PLANNING DEPARTMENT – Development Review Services

**RE: Sevilla @ Andalucia - (File: F11D015C)**  
**Drainage Management Plan, Engineer's Stamp Date 1-19-2015**  
**Grading and Drainage Plans, Engineer's Stamp Date 1-19-2015**

Re: Response to Comments  
Drainage Master Plan for Sevilla @ Andalucia

# DRAINAGE MASTER PLAN FOR SEVILLA @ ANDALUCIA

| SEVILLA AT ANDALUCIA<br>GRADING PLAN |                        |                                                                      |    |

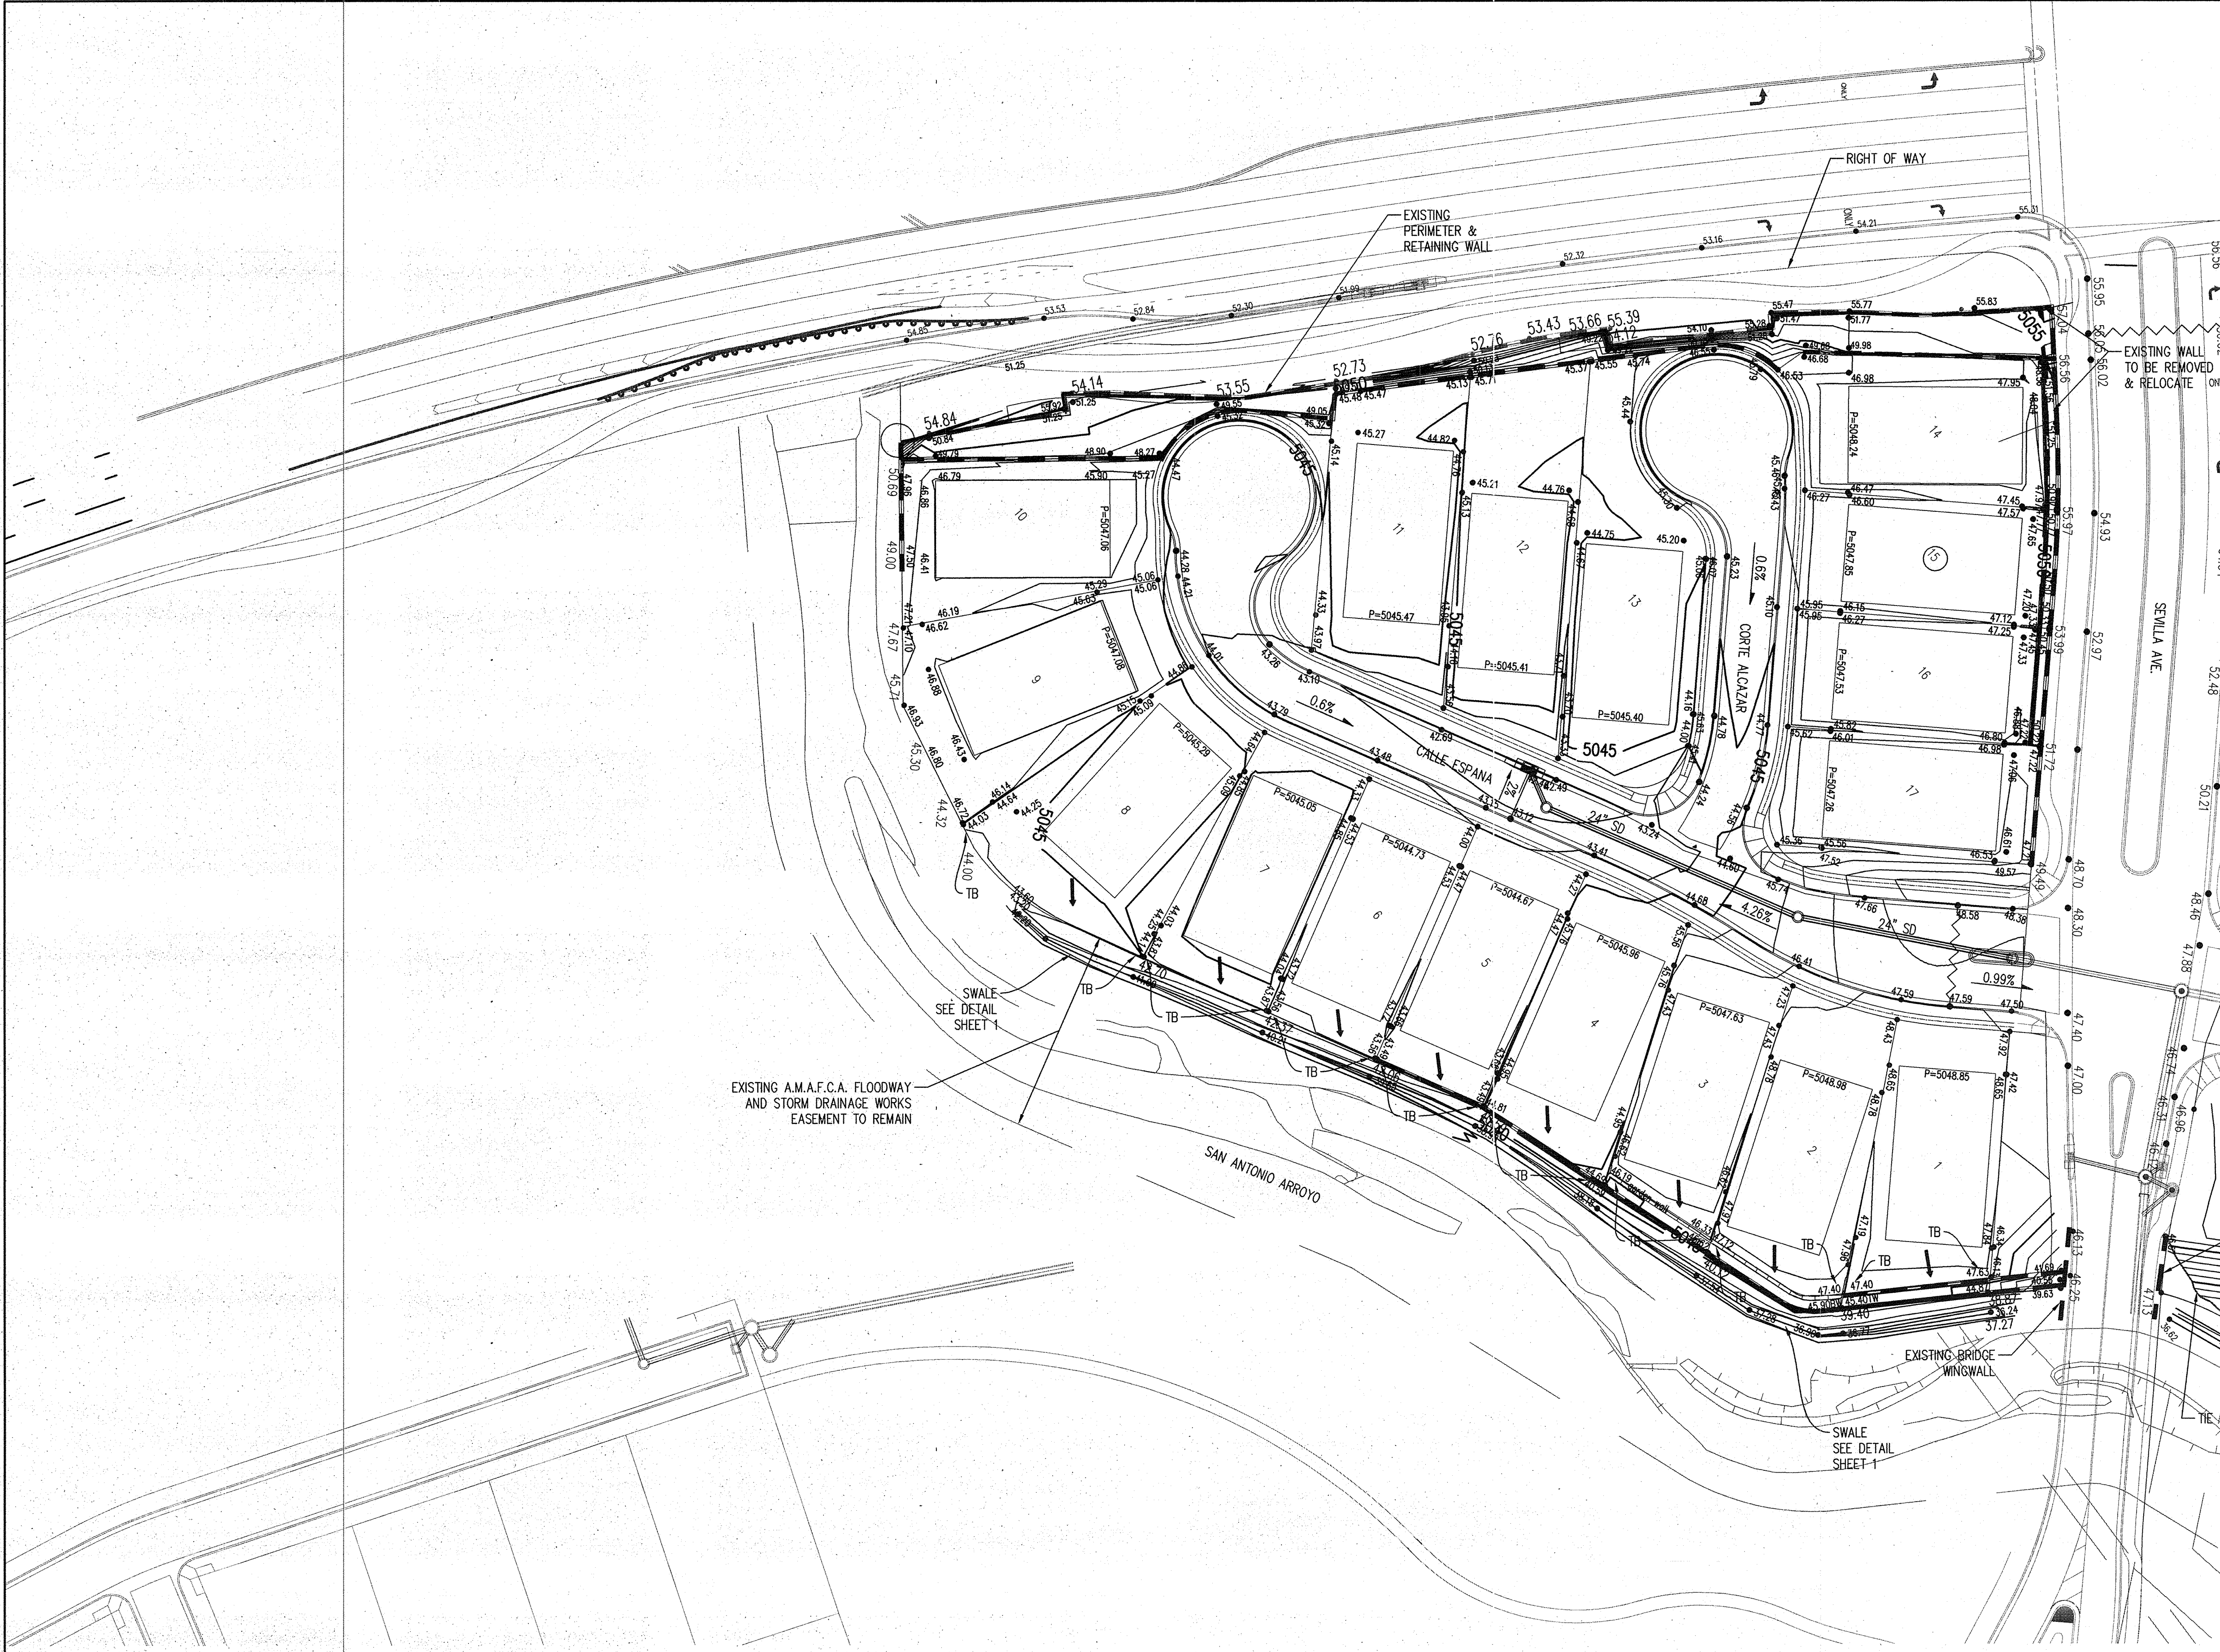
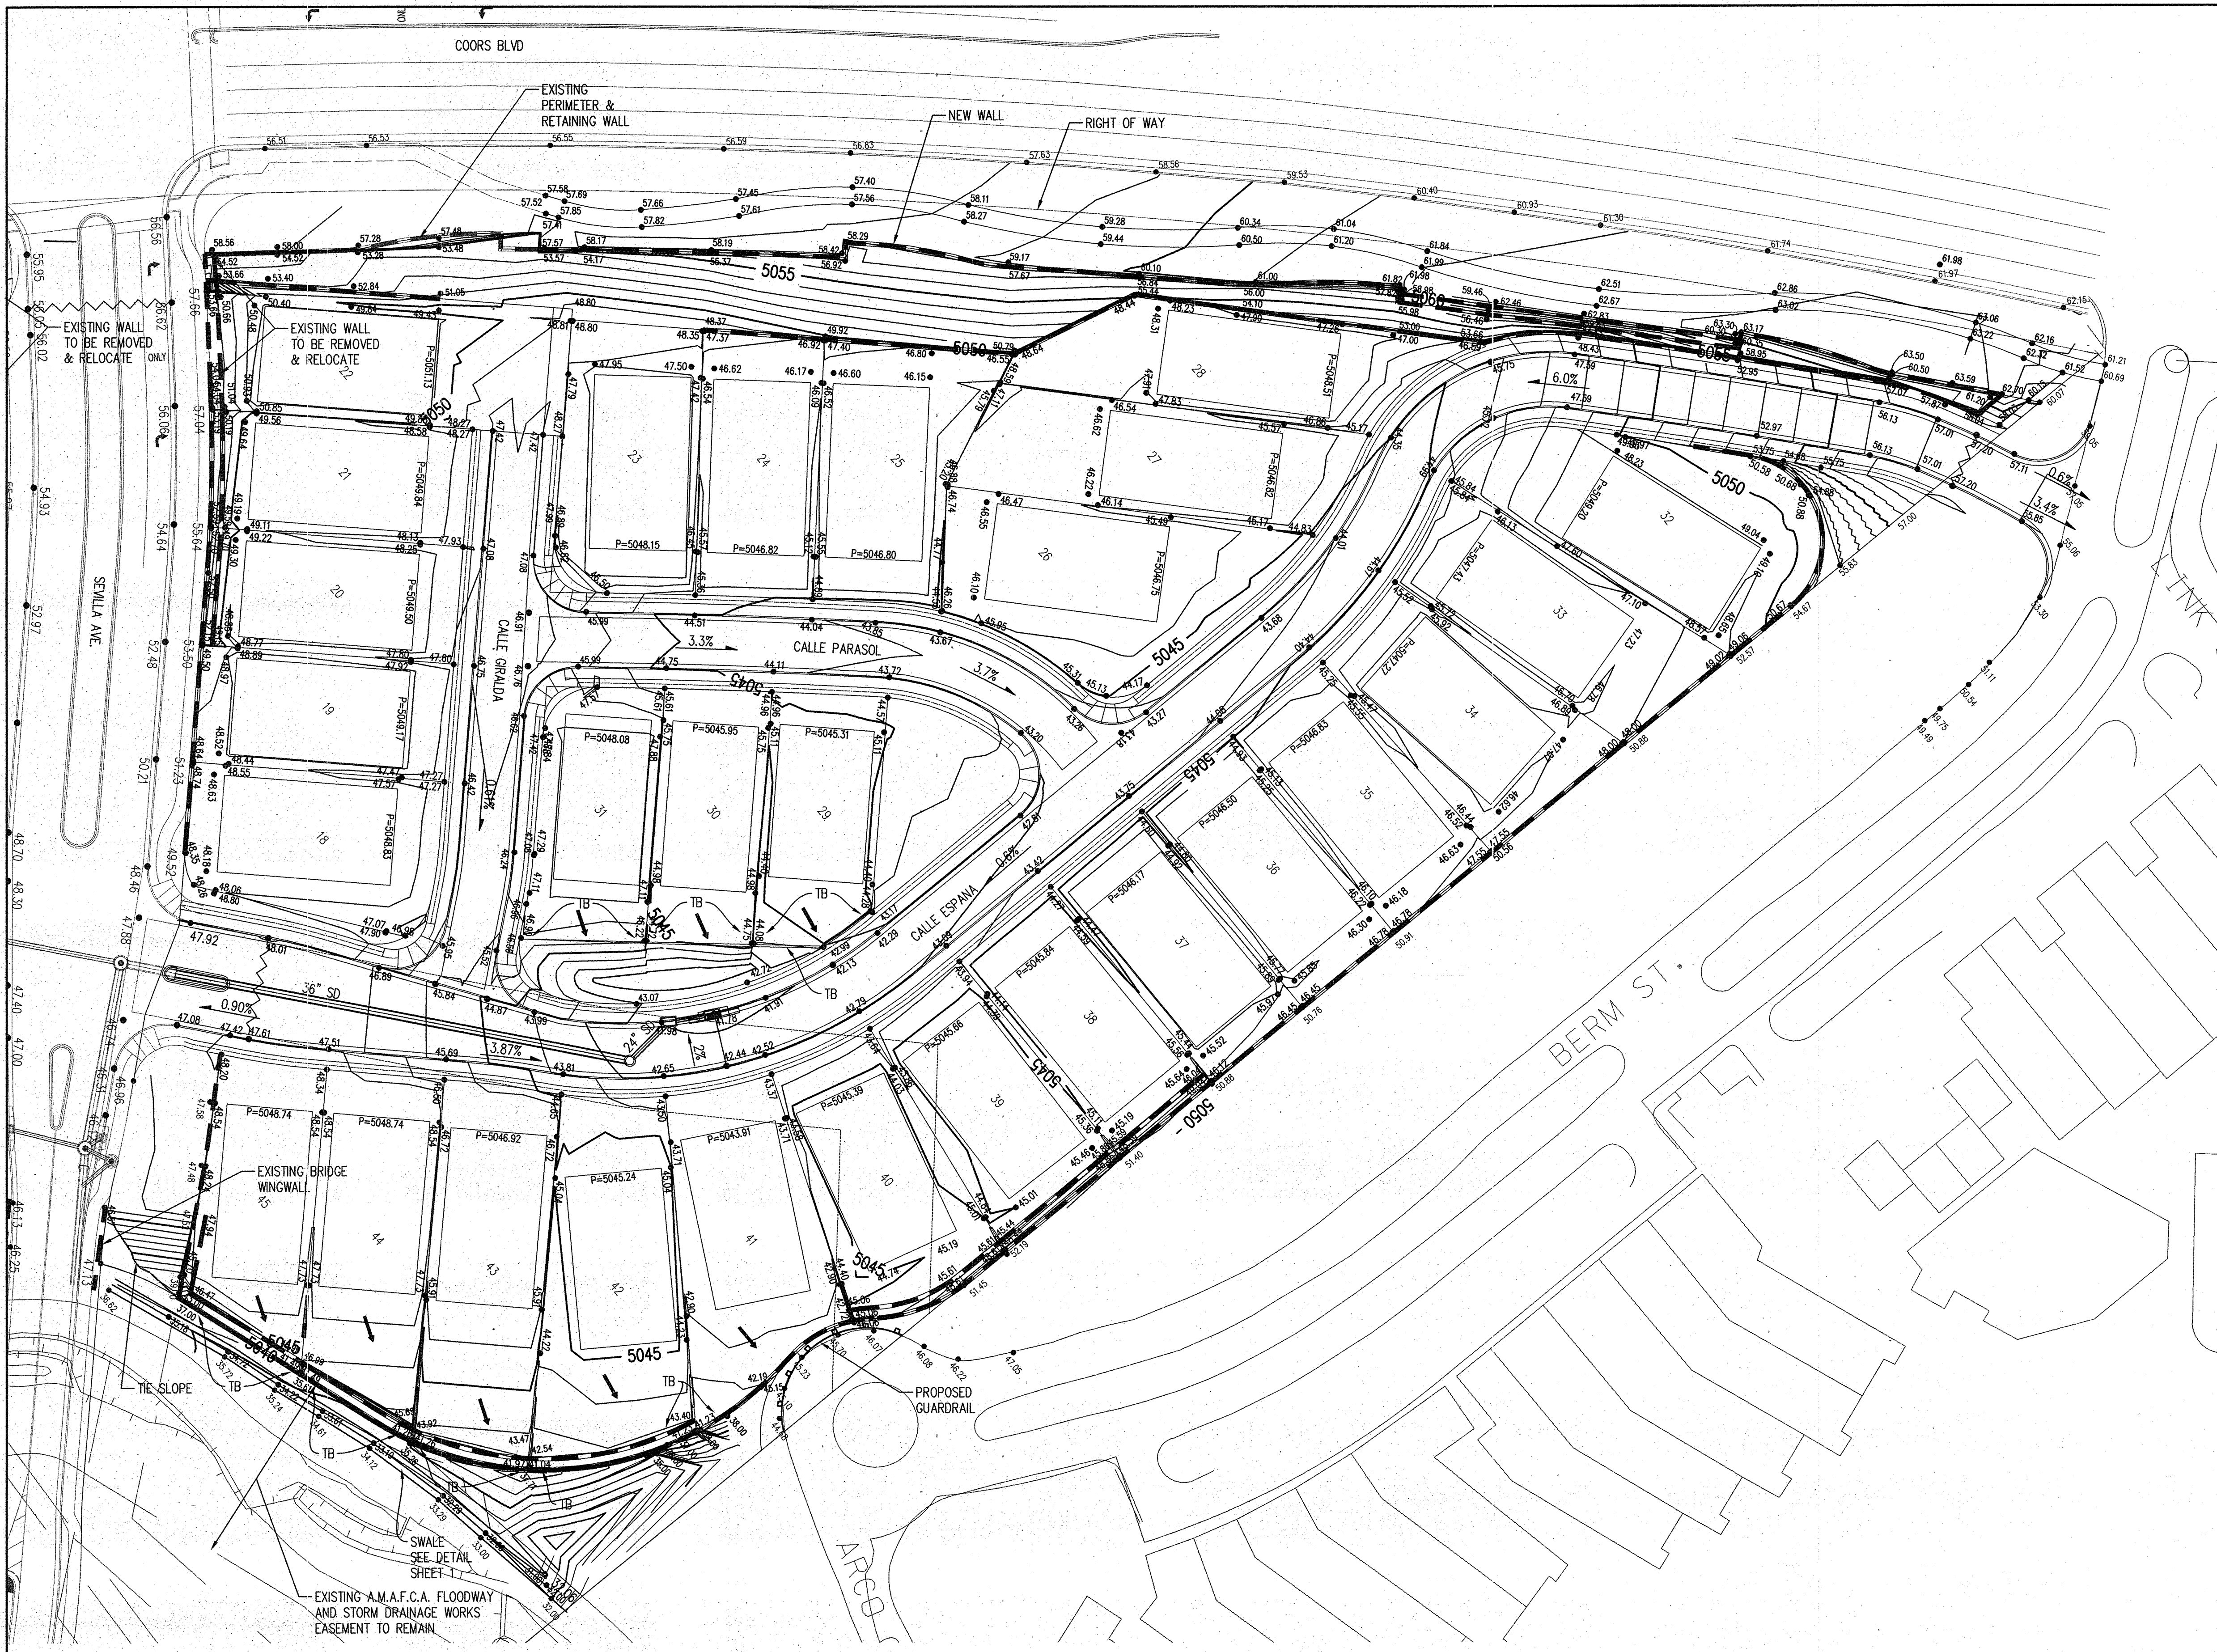
1. Open space tract ~~at~~ Basin D-1 should drain to cul-de-sac at far south end via turned blocks or other means.

3. Grading plan does not show the existing elevations of Sevilla Ave. It seems to show historic contours. Show existing contours and flowline of Sevilla Ave. Is there a water block from Coors into Sevilla Ave?

- **Grading Plan has been revised to more clear show Coors Blvd Line Work. Flowline elevations have also been shown for reference**
9. Do flows on East side of Coors (in meandering sidewalk area) drain to this site? Particularly north of Sevilla Ave? The developed basin map shows flow arrows pointing west, but the contours do not support this. There seems to be some ponding in this area. Where is the R.O.W.? Where is the property line? How does this area drain?

10. Is the Retaining wall along Coors existing or proposed? Are both walls shown retaining walls? Site Plan for Subdivision suggests that the wall closer to wall is a decorative wall.

12. Show proposed contours.
  - **Grading Plan has been revised to reflect this.**
13. Show top and bottom of wall elevations on Retaining walls on Grading Plan.

19. Indicate location and opening area of "Turned blocks" on the grading plan.
- **Grading Plan has been revised to reflect this.**
20. Clearly show AMAFCA Floodway and easements as well as the boundary of the SFHA A flood zone.

21. Show slopes of roadway on Grading.
- **Grading Plan has been revised to reflect this.**
22. Provide Road cross sections.
- **Grading Plan has been revised to reflect this.**

23. Indicate on the Grading plan where standard curb and mountable curb will be used.
- **Note has been added to the grading plan that all curb and gutter is Standard.**

- **Yes, there is a water block just east of Coors on Sevilla. The grading plan has been revised to with additional spots confirming the water block.**

- **Area west of the wall in Coors Blvd drains towards Coors Blvd. Basin Map and Grading Plan have been updated to show this. ROW has been labeled on Grading Plan.**

- **The wall along Coors Blvd south of Sevilla is existing and has a 4' retaining wall built into the wall, where the development site is lower than Coors. On the north side of Sevilla, a portion of the wall is built for approximately 150' to the north and also has a 4' retaining wall built into it similar to the south side. The wall is proposed to continue from the existing terminus of the wall to the north property boundary. Grading Plan notes have been added to reflect this.**

- **Grading Plan has been revised to reflect this.**
14. Legend shows existing storm drain system with hatched pattern, but is actually faded on plan.

18. Show on the Grading Plan the earth lined swales that Basins B and F and K drain to as indicated in the report.
- **Grading Plan has been revised to reflect this.**

- **The grading plan has been revised to show retaining walls, existing bridge wingwalls and contours to show more clarification in this location.**
